**MODIFICATION 01 - JUNE 2020**  
**SCHEDULE OF CHANGES**

32 The Strand Whale Beach				
SUMMARY OF BASIX COMMITMENTS				
This is a summary of the BASIX Commitments as detailed in the BASIX Certificate. Refer to the CURRENT BASIX Certificate for Complete details. For definitions refer to basix.nsw.gov.au				
WATER COMMITMENTS				
Fixtures				
3 Star Shower Heads		Yes ( > 4.5 but <= 6 L/min)		
5 Star Kitchen / Basin Taps		Yes	4 Star Toilet	Yes
Alternative Water				
Minimum Tank Size (L)		3000	Collected from Roof Area (m2)	70
Tank Connected To:				
All Toilets		Yes	Laundry W/M Cold Tap	Yes
One Outdoor Tap		Yes		
THERMAL COMFORT COMMITMENTS - Refer to TPA Specification on plans				
ENERGY COMMITMENTS				
Hot Water		Solar (Electric Boost) 21 to 25 STCs		
Cooling System	Living	1 Phase A/C Zoned		EER 2.5 - 3.0
	Bedrooms	1 Phase A/C Zoned		EER 2.5 - 3.0
Heating System	Living	1 Phase A/C Zoned		EER 2.5 - 3.0
	Bedrooms	1 Phase A/C Zoned		EER 2.5 - 3.0
Ventilation	1 x Bathroom	Fan ducted to exterior		Manual on/off

4 section  
200.01 1: 100

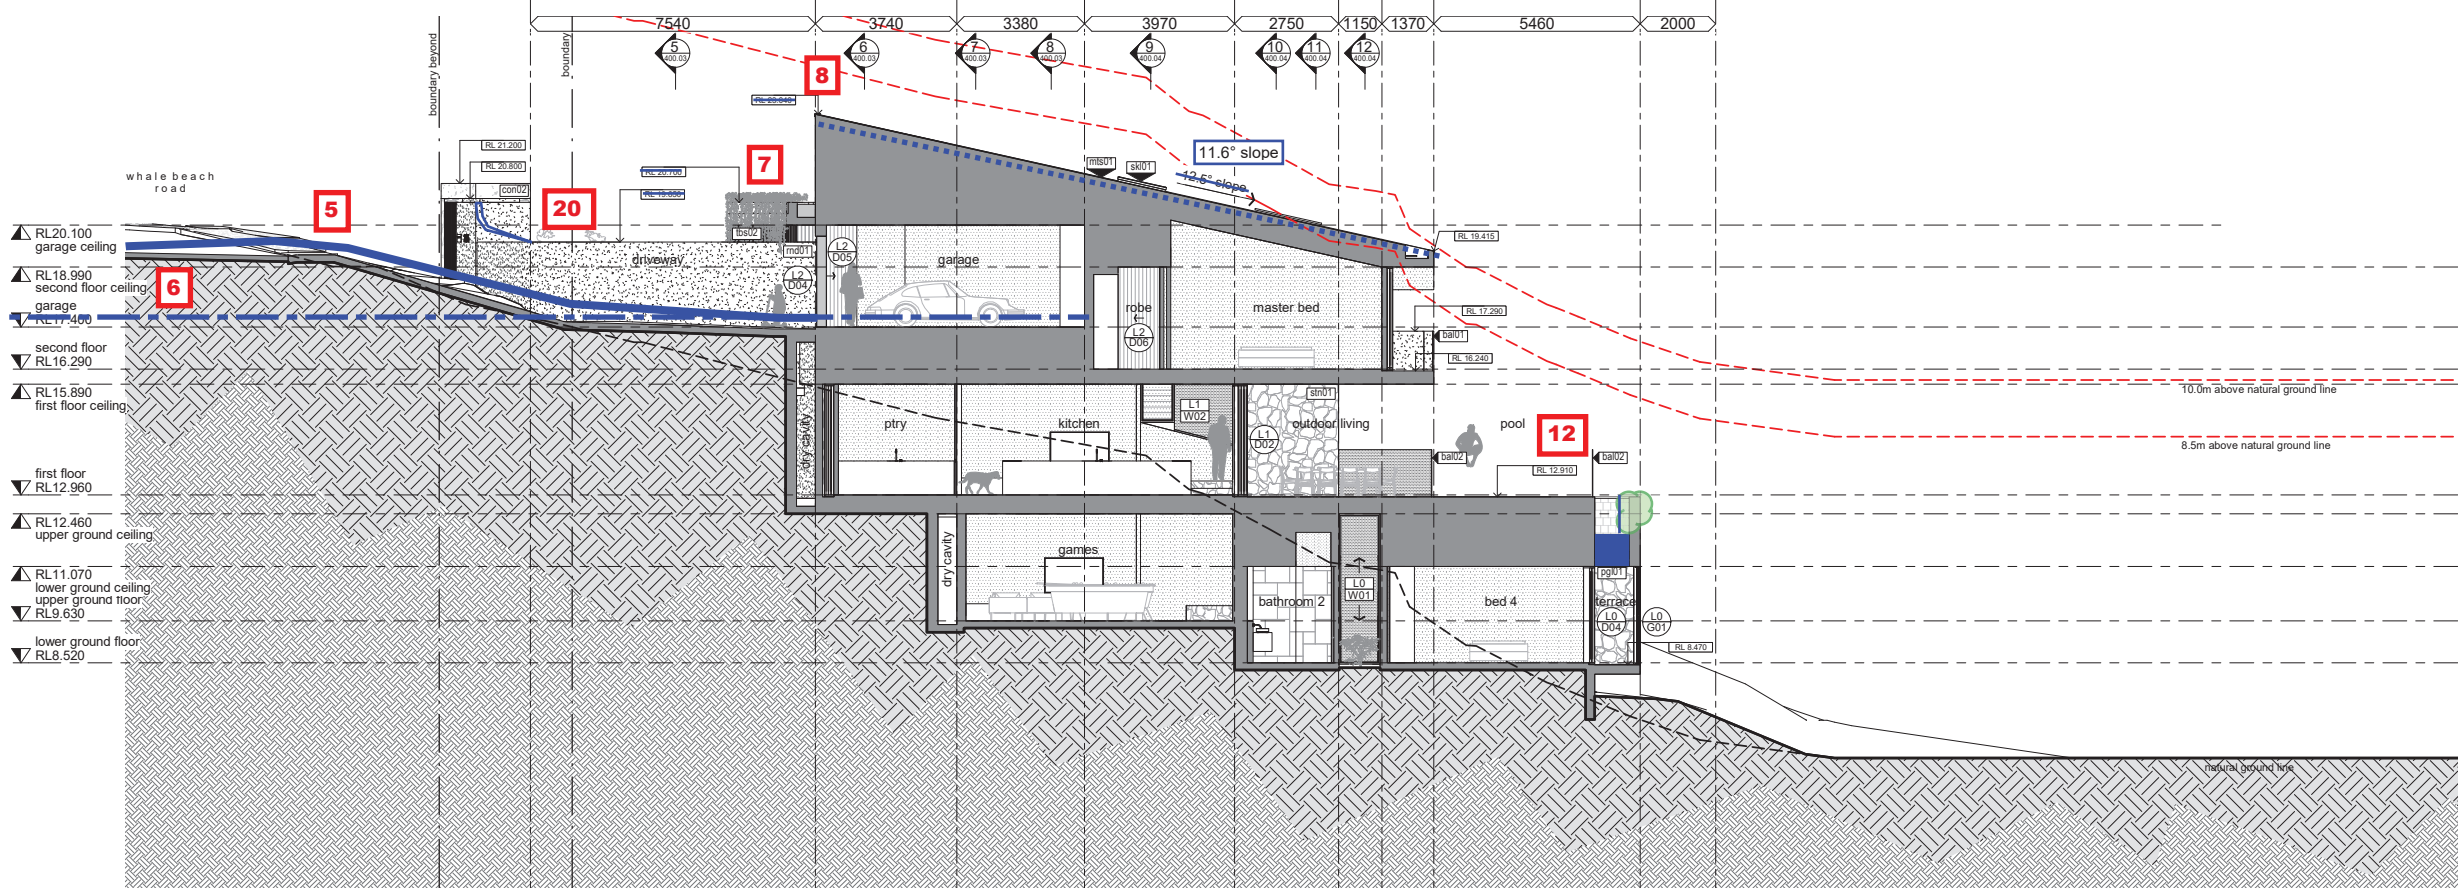
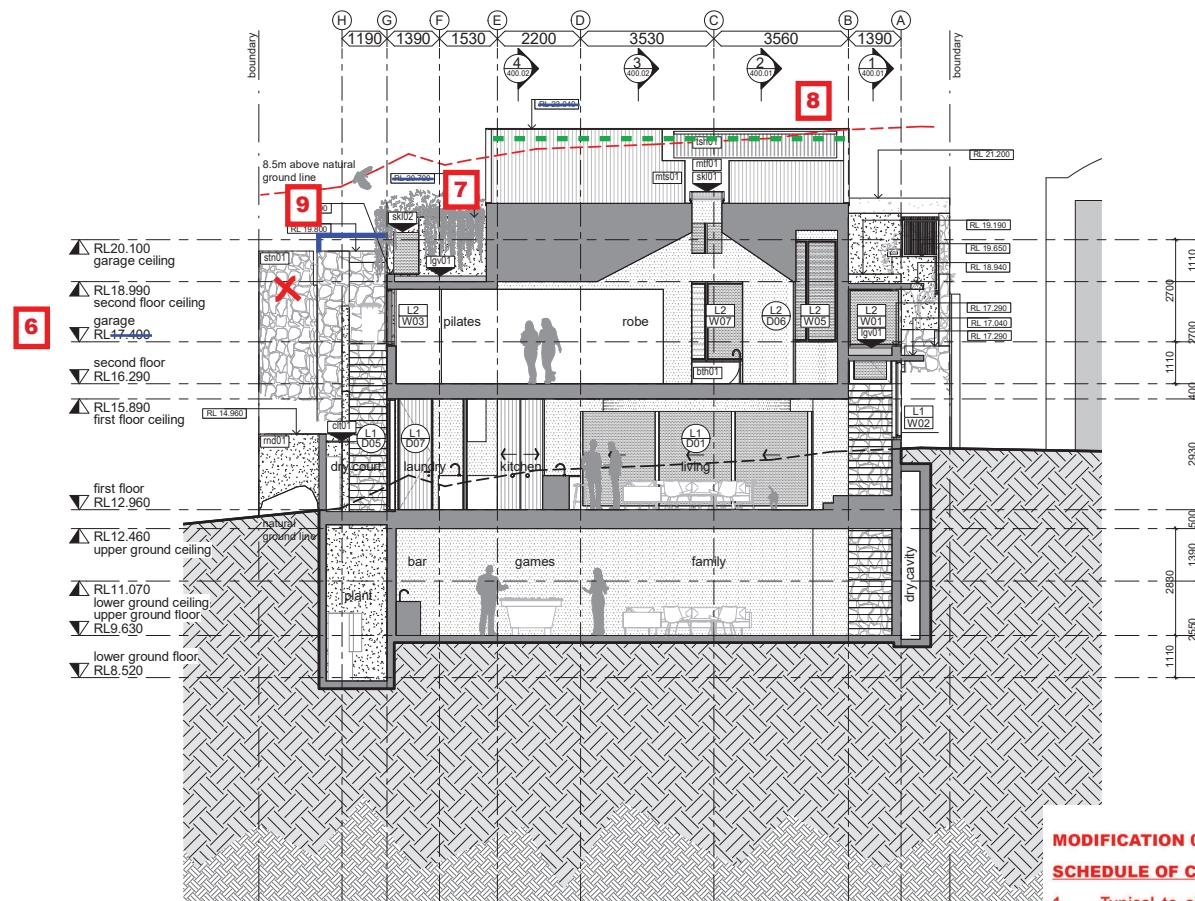
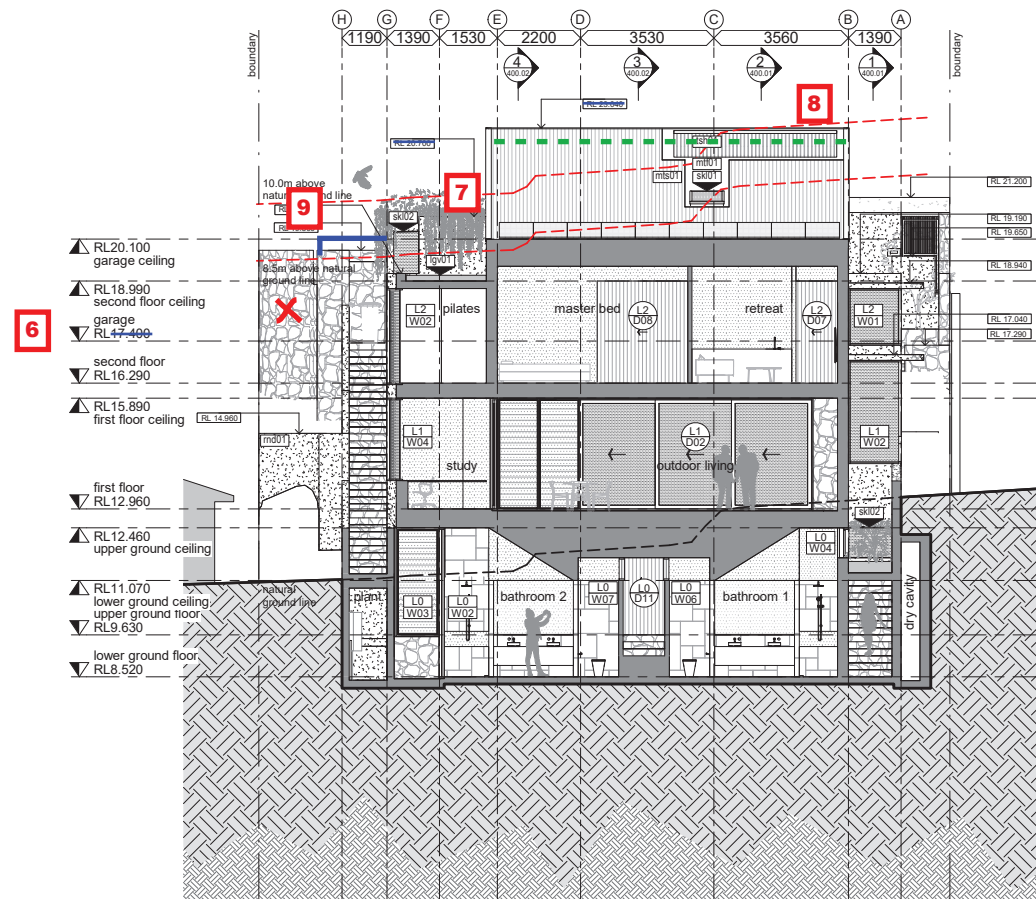
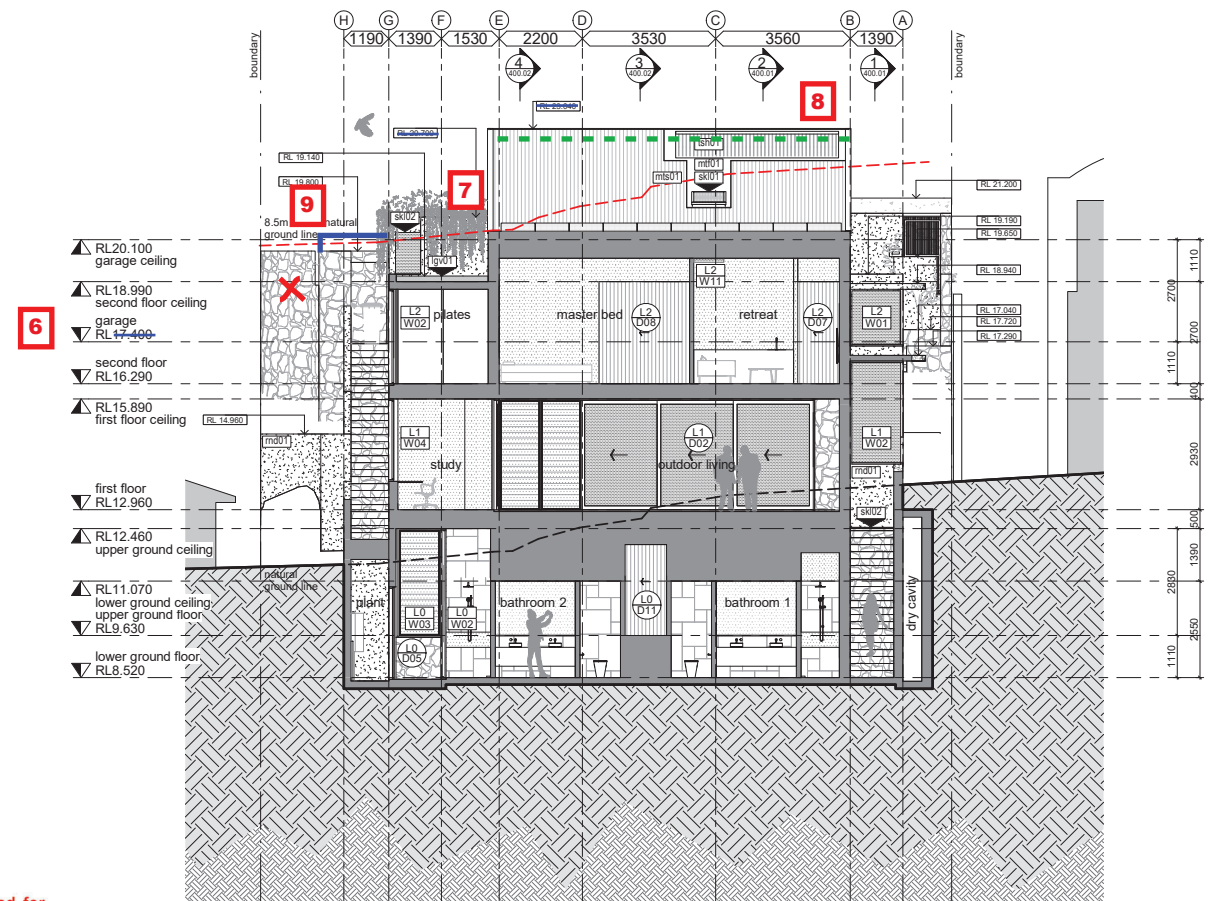
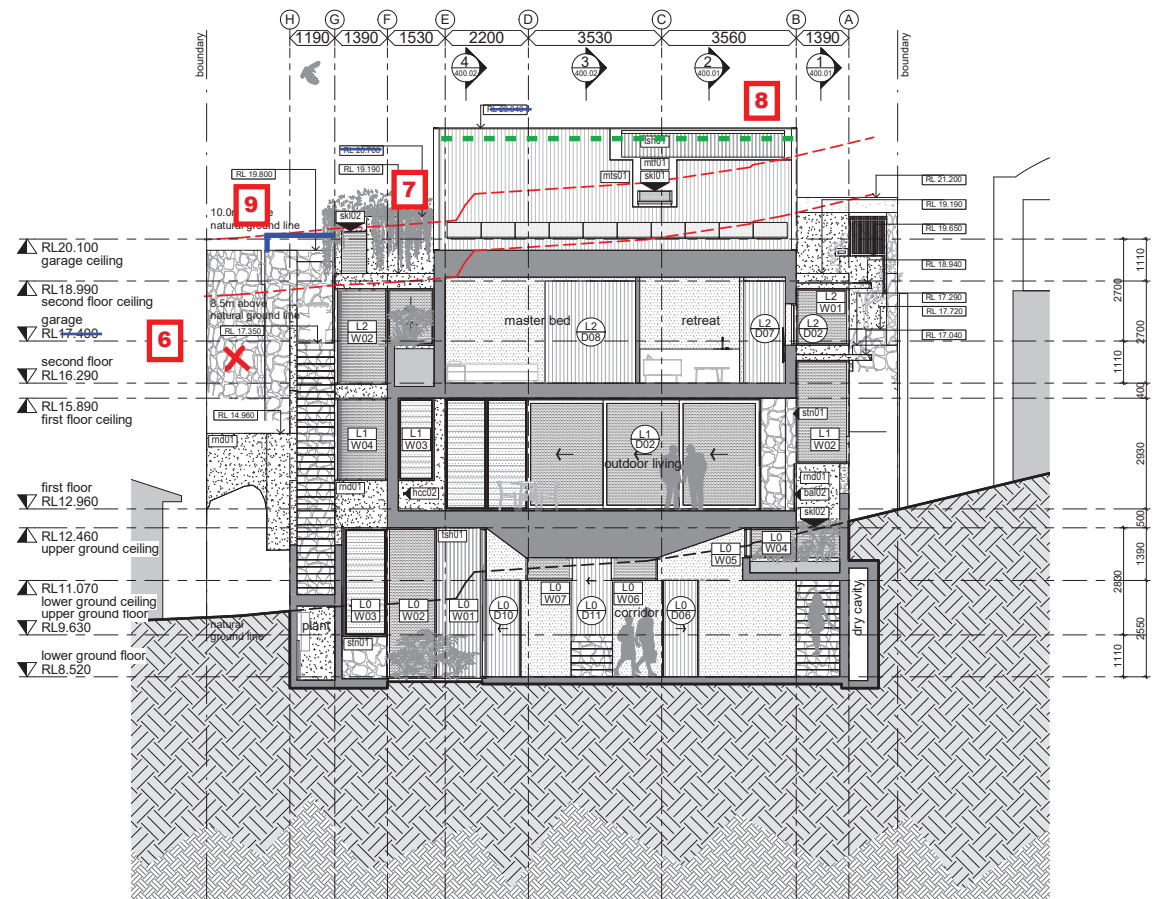
1. Typical to all external areas: stone floor paving substituted for conventional shaped natural stone tile
2. Typical to all internal areas: stone floor paving substituted for timber floors, and conventional shaped natural stone tiles in wet areas

3. Hard path and steps removed from architectural scope. Soft landscaping solution by landscape architect
4. Driveway finish changed and widened in accordance with consent SL2020/0241

5. Driveway levels modified to suit Council requirements in accordance with consent SL2020/0241. Car turntable added
6. Garage level raised by 300mm to RL17.700 as a result of accommodating [5]

7. Garage roof and garden edge lifted 150mm to RL20.850 as a result of accommodating [5] and [6].
8. Main roof ridge lowered by 290mm to RL22.750 as a courtesy to improve the view amenity of a neighbour to the west. Roof slope adjusted to 11.6 degrees.

9. Bin store reshaped and curved wall deleted. Bin store lid level shown at RL20.150. Refer to plans for dims where appropriate. Alteration in part as a result of compliance with prescribed conditions of consent (23) + (25) relating to tree protection and arborist's recommendations.

10. Minor alteration to configuration of glazing. Fixed glass to study. Glazed swing door out of laundry. Note net area and amount of glass remains unchanged.

11. Minor alteration to configuration of glazing. Refer to plan for relocation of walls. Note net area and amount of glass remains unchanged. floor area slightly reduced.

12. Swimming pool infinity edges (and associated ballast tank) deleted and zone changed to accessible path and landscaped wall/planter
13. Steps introduced to pool terrace to access service path . Refer to plans for dims where appropriate.

14. Extra solar panels added to increase energy efficiency of development
15. Block wall moved down to align with pool equipment adjacent as shown. Note this change is underground and not visible to the public or neighbours.

16. Plant and equipment store area increased by moving western wall further west in order to accommodate the required equipment with ventilation and service space. Refer to plans for dims where appropriate.

17. Block wall to be changed to screening for ventilation and sound attenuation
18. Seat added
19. Landscape plan amended in accordance with prescribed conditions of consent (15) + (38).

20. Height of landscaped wall facing street to be increased to the North to a max height of 1800mm above ground level to follow natural topography.

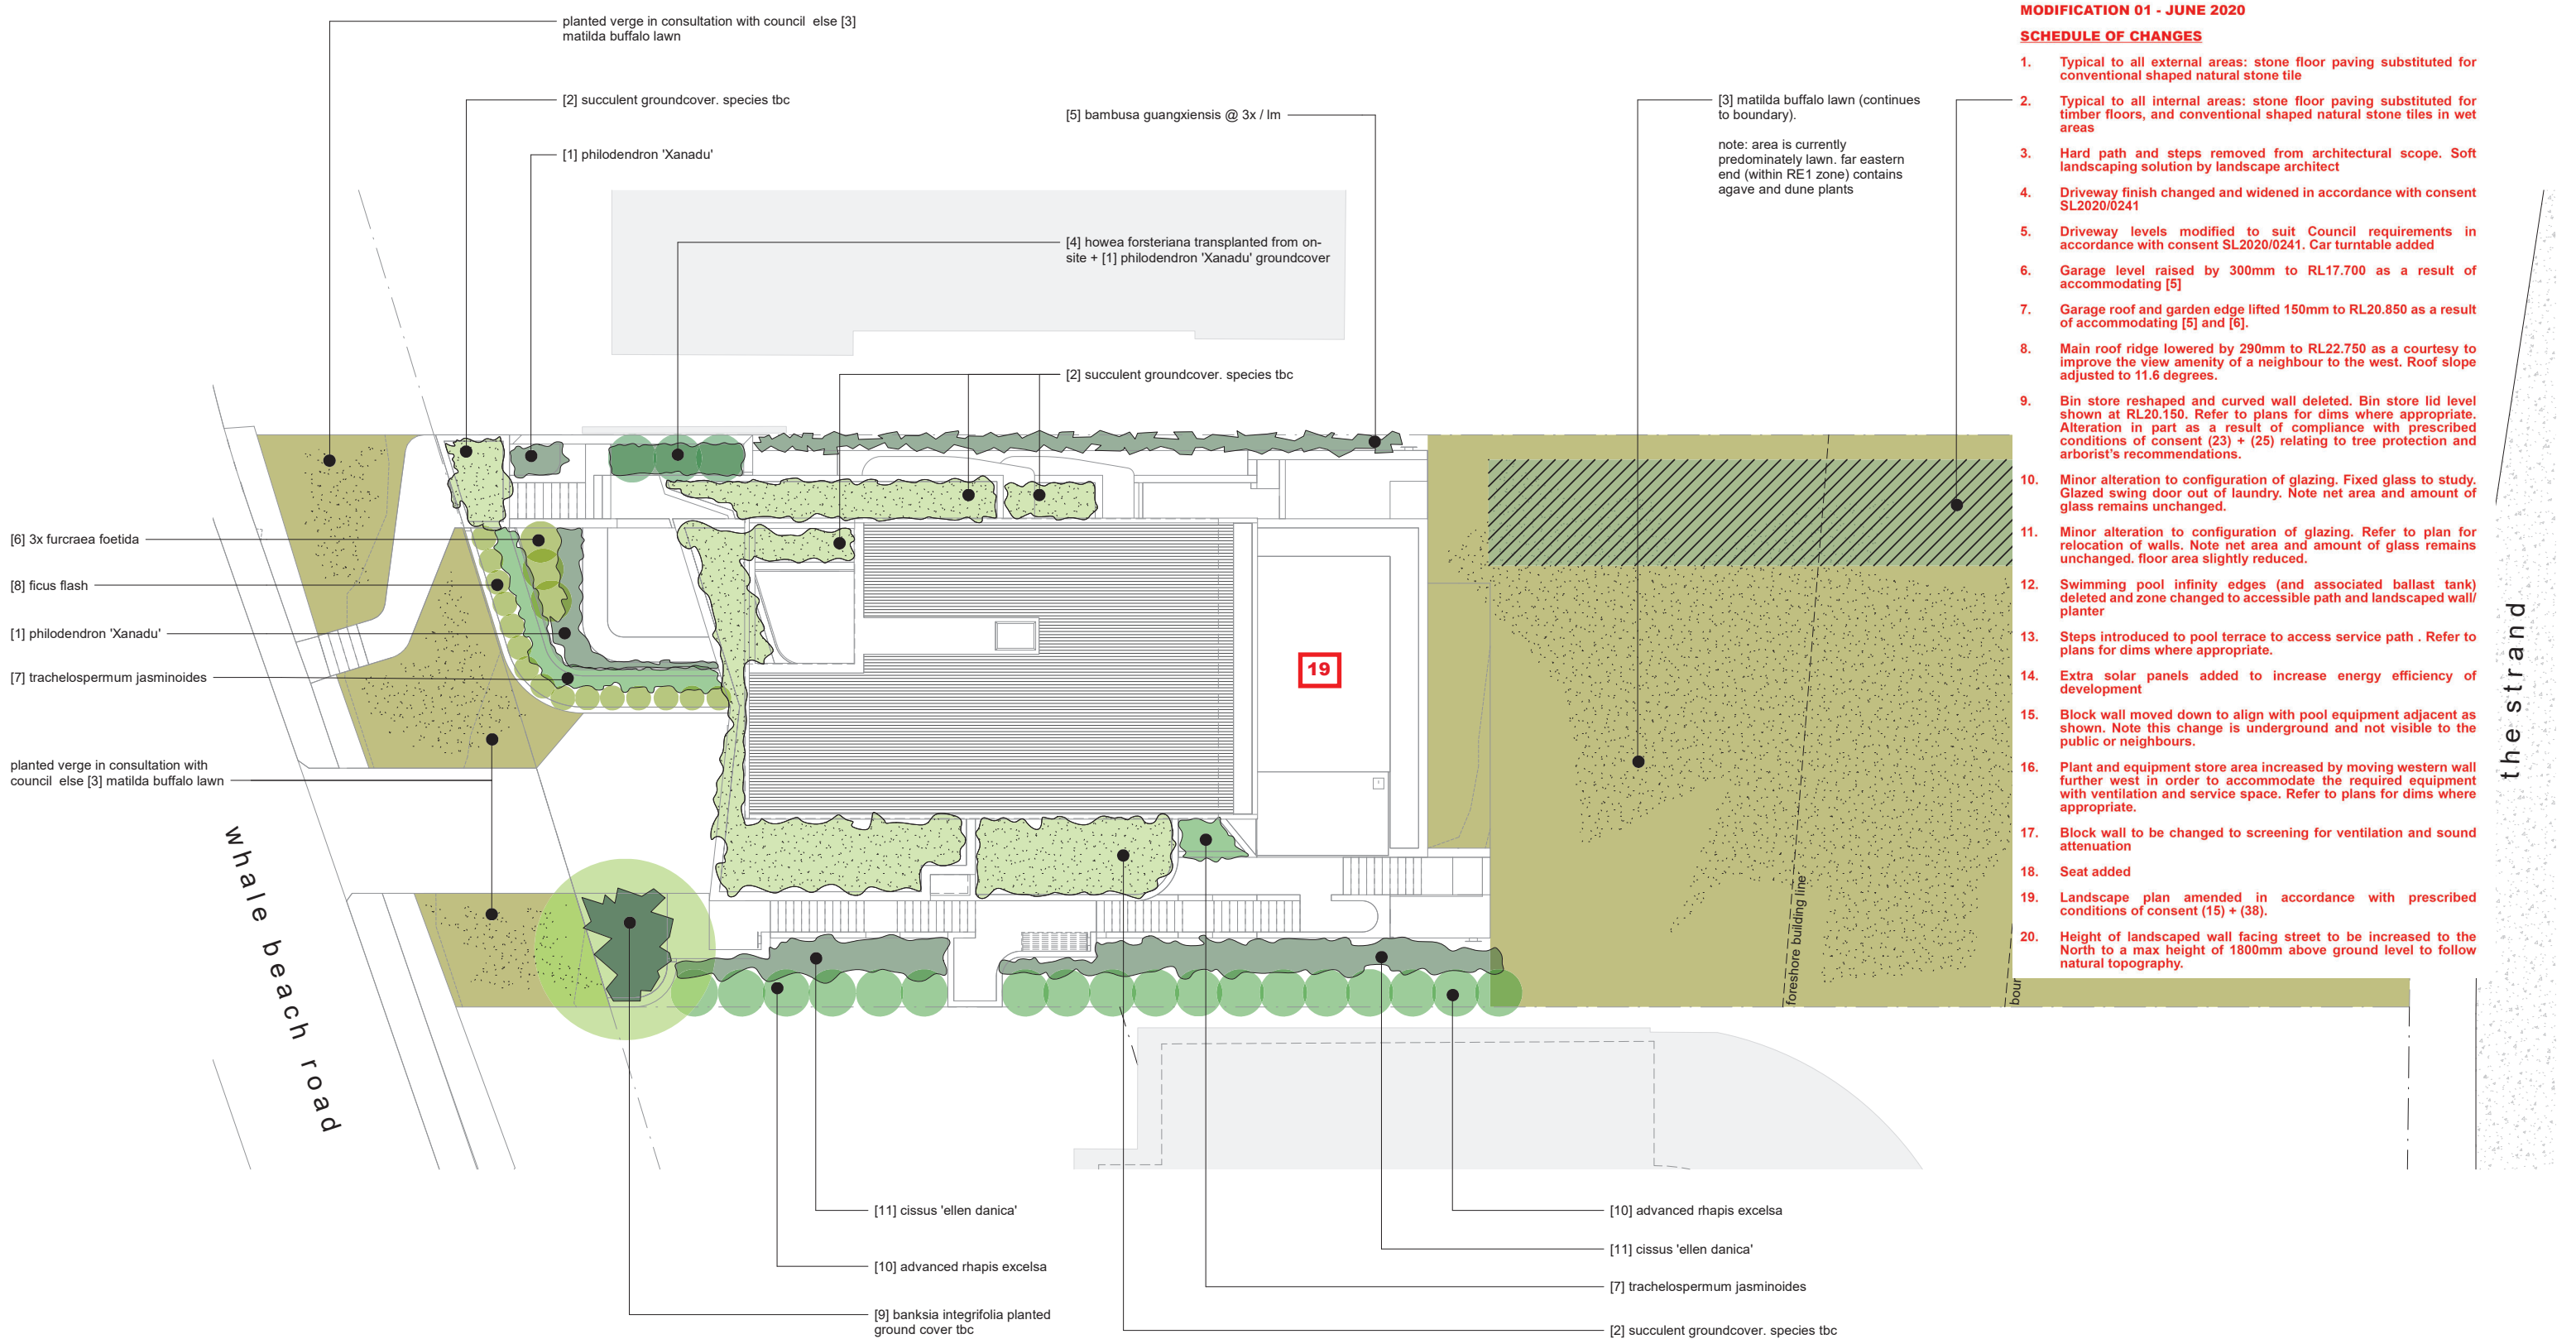
1. Typical to all external areas: stone floor paving substituted for conventional shaped natural stone tile
2. Typical to all internal areas: stone floor paving substituted for timber floors, and conventional shaped natural stone tiles in wet areas

3. Hard path and steps removed from architectural scope. Soft landscaping solution by landscape architect
4. Driveway finish changed and widened in accordance with consent SL2020/0241

5. Driveway levels modified to suit Council requirements in accordance with consent SL2020/0241. Car turntable added
6. Garage level raised by 300mm to RL17.700 as a result of accommodating [5]

7. Garage roof and garden edge lifted 150mm to RL20.850 as a result of accommodating [5] and [6].
8. Main roof ridge lowered by 290mm to RL22.750 as a courtesy to improve the view amenity of a neighbour to the west. Roof slope adjusted to 11.6 degrees.

9. Bin store reshaped and curved wall deleted. Bin store lid level shown at RL20.150. Refer to plans for dims where appropriate. Alteration in part as a result of compliance with prescribed conditions of consent (23) + (25) relating to tree protection and arborist's recommendations.

10. Minor alteration to configuration of glazing. Fixed glass to study. Glazed swing door out of laundry. Note net area and amount of glass remains unchanged.

11. Minor alteration to configuration of glazing. Refer to plan for relocation of walls. Note net area and amount of glass remains unchanged. floor area slightly reduced.

12. Swimming pool infinity edges (and associated ballast tank) deleted and zone changed to accessible path and landscaped wall/planter
13. Steps introduced to pool terrace to access service path. Refer to plans for dims where appropriate.

14. Extra solar panels added to increase energy efficiency of development
15. Block wall moved down to align with pool equipment adjacent as shown. Note this change is underground and not visible to the public or neighbours.

16. Plant and equipment store area increased by moving western wall further west in order to accommodate the required equipment with ventilation and service space. Refer to plans for dims where appropriate.

17. Block wall to be changed to screening for ventilation and sound attenuation
18. Seat added
19. Landscape plan amended in accordance with prescribed conditions of consent (15) + (38).

20. Height of landscaped wall facing street to be increased to the North to a max height of 1800mm above ground level to follow natural topography.
